Edith Road Project.

Cosmur Construction Limited.

Contractors Proposal - Biosolar Roof; Planning Condition 12 rev 2

Date: 26-Jan-23

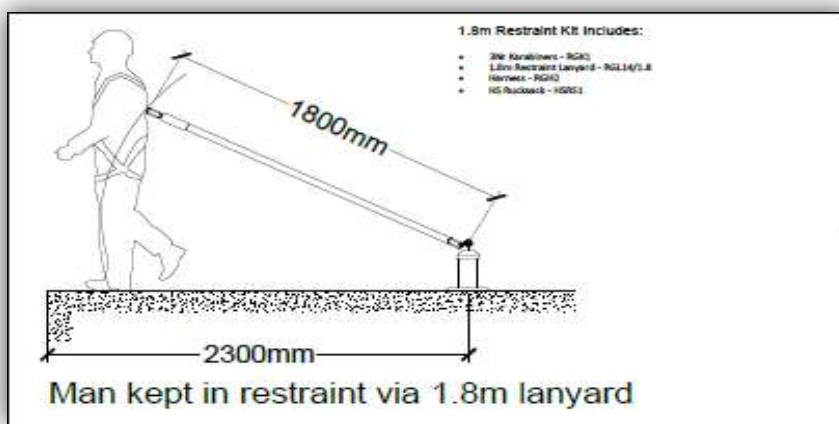
10. It is important to note that a constant force post and rail system further restricts PV area on the roof as it has to be off-set from the edge as shown below:

Also, a corridor of 600mm would be required through rows of PV's.

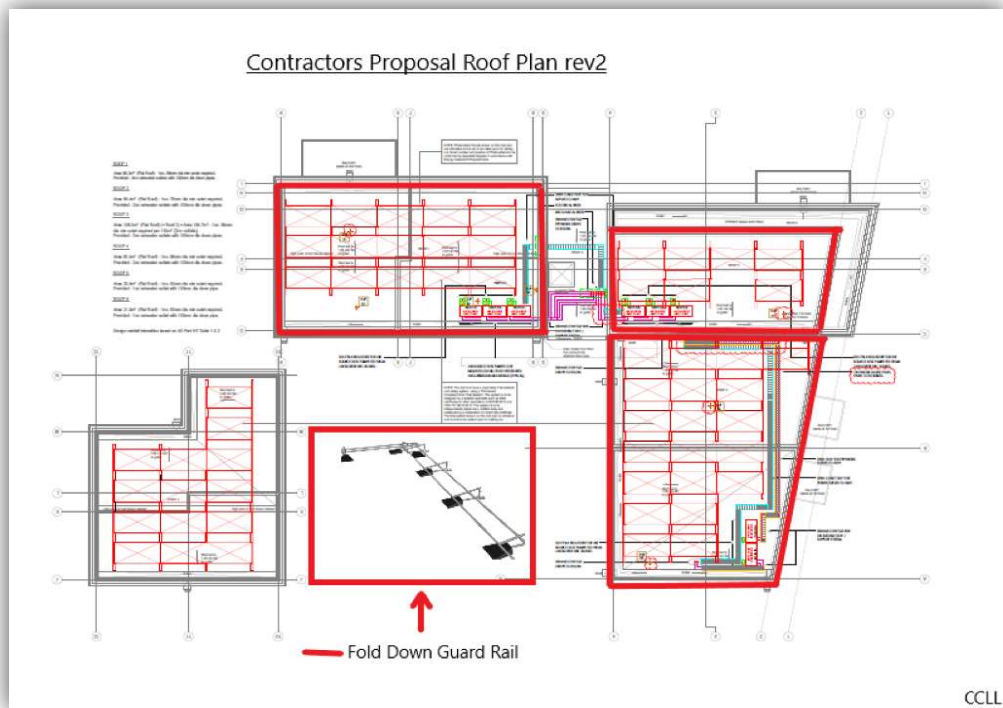
Optigreen's correspondence is attached although in summation they could only achieve an output of 21,535 Kw/h. Again, this being non-compliant. A snapshot below visualises their proposal and as you can see there is no further scope to increase the number of modules/cells:
